Schmid & Company, Inc., Consulting Ecologists
1201 Cedar Grove Road
Media, Pennsylvania 19063-1044
(610) 356-1416 FAX: (610) 356-3629
www.schmidco.com

6 September 2011

In re: Comments on DSEA Permit Application E5729-014

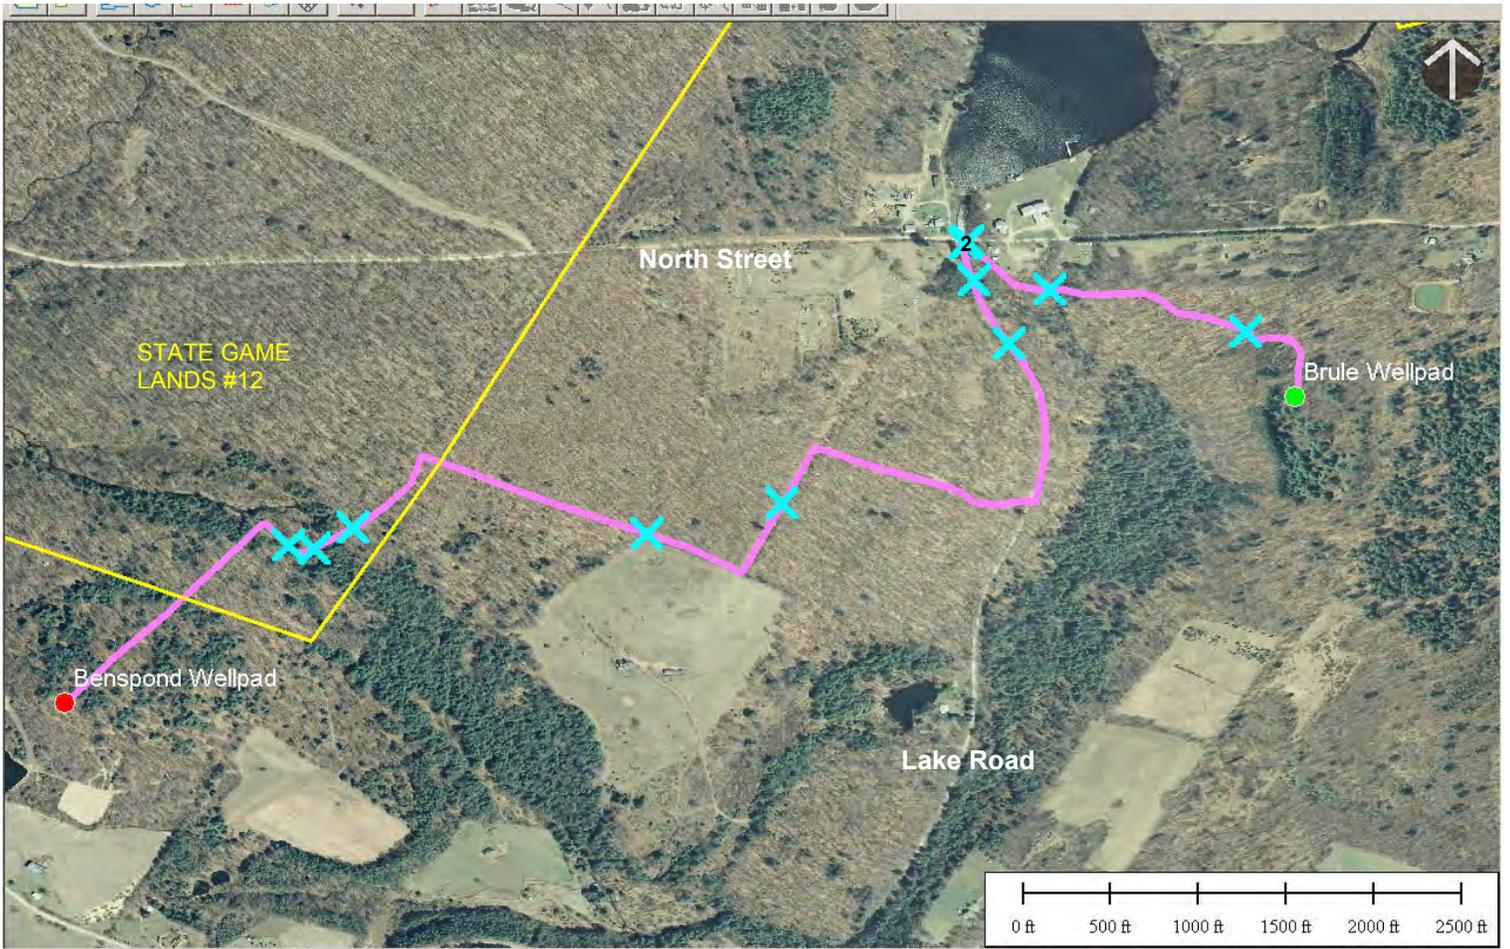
One prime example is the acknowledged crossing of wetlands adjacent to Elk Creek (Impact #1) which reportedly involves 2,561 square feet of wetland disturbance. A slight adjustment in the route about 35 feet westward on the west side of Elk Creek would reduce the proposed wetland impact by about half and also would avoid much of the regulated floodway. No explanation is given why the westward shift would not be feasible or was not proposed.

The boilerplate discussion claims that “[s]ignificant effort ... was taken to first avoid, and then minimize, impacts to wetlands and streams during the routing” design. “In particular, impacts to wetlands or streams, especially EV waters, are avoided where possible.” Yet the application offers no documentation of alternative routes that might have been considered but were dismissed as being more environmentally damaging. Inasmuch the proposed route (Figure 1) involves crossing four EV wetlands, and between seven and nine (depending upon which section of the application is to be believed) crossings of EV waterways, it is unclear whether the chosen route truly avoids and minimizes impacts to the maximum extent. Two obvious alternatives (see A and B on Figure 2) would appear to require significantly shorter overall distances and have fewer impacts to wetlands, streams, and undisturbed forestland. Why

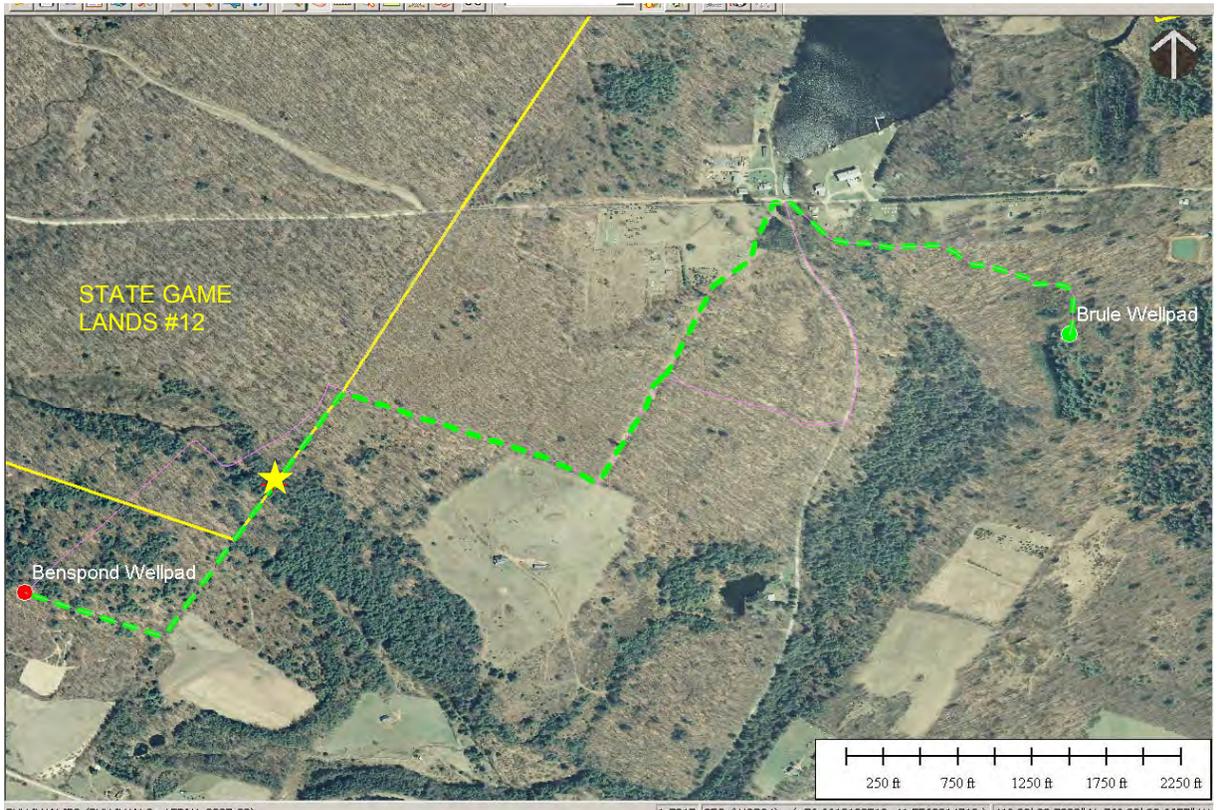
those routes were not considered, or if they were, why they were not chosen, should be discussed.

5. Require the applicant to expand the alternatives analysis to provide specific information about alternative routes considered and rejected, and to compare the impacts associated with those alternatives with the chosen route.
